DEVELOPMENT CONTROL COMMITTEE

22 APRIL 2021

COUNCILLORS' ADDITIONAL PAPERS

INDEX OF DOCUMENTS CIRCULATED AFTER PUBLICATION OF THE AGENDA

5-CG-G
100.03 -C

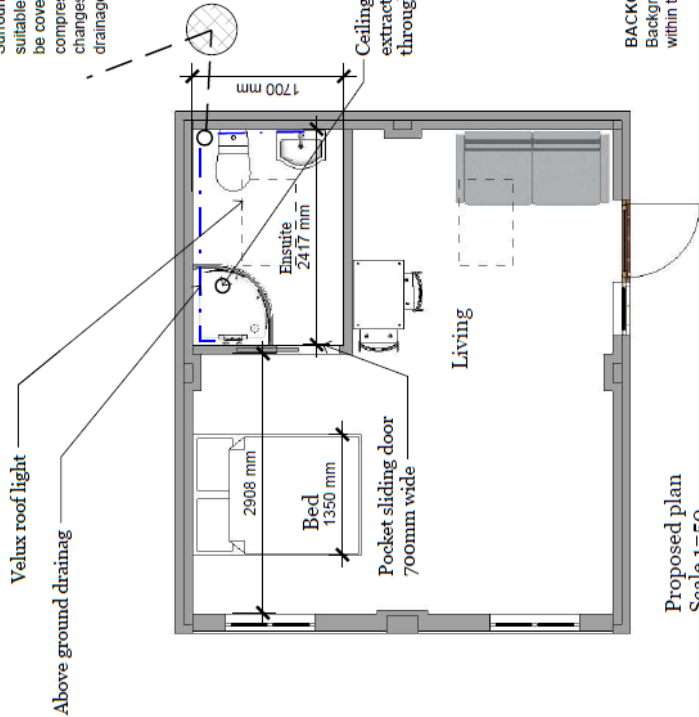
- The meaning of 'integrated' within Plan:MK Policy D6.
- References to a kitchen related installations on the text of the proposed plan.

- Accessibility of the annexe (no wheelchair door)
- Shared access

It is noted that this a revised plan with removal of a kitchen which could easily be installed at a later date. The specification still listed on 5CG – Garage – G100.03-B shows above ground drainage installation for washing and dishwasher as well as sinks. The sofa has been placed in this position where the kitchen was intended to be, why was this removed?

The 900mm door is a standard opening and if the annex is for an elderly parent who may in time need wheelchair access through a 1200mm opening, why isn't this been considered / future proofed?

- Text relating to the original kitchen installation has been removed from the proposed plans in a revised drawing (shown below).
- Regarding accessibility and the door not being wheelchair friendly, there is no reason to assume that an elderly parent would necessarily be wheelchair bound and, as stated in the application description, the converted annexe might be used by a carer.

As discussed above, an amendment of the proposed plan has been received removing text references associated with the original kitchen installation.

B- Kitchen omitted

C- Notices amended
